TECHNICAL BULLETIN

Mini

Bulletin N°: **0009**
CDS. ref: **X8499bu**
Issue: **2**
Date: **5.07.2000**

COOLANT - CHANGE TO SPECIFICATION

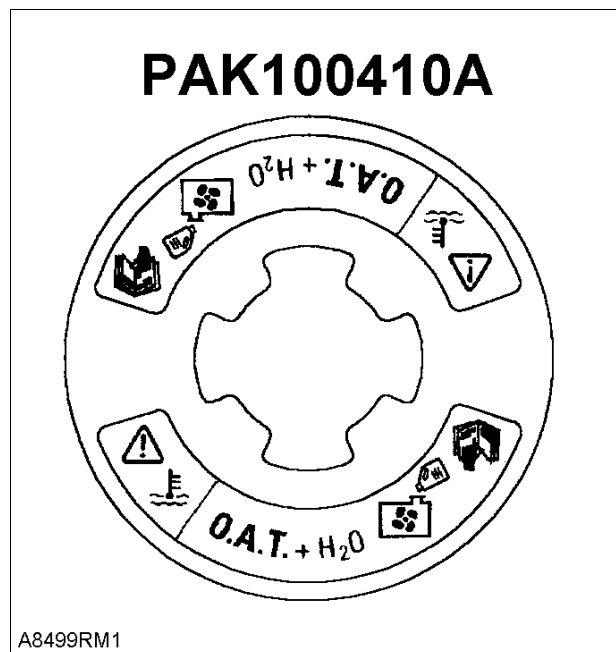
When Unipart OAT (XLC) coolant has been added to such a vehicle it will be necessary to replace the existing black filler neck label with the OAT warning label coloured yellow, part number PAK100410A (see illustration). This will indicate that coolant specification has been changed.
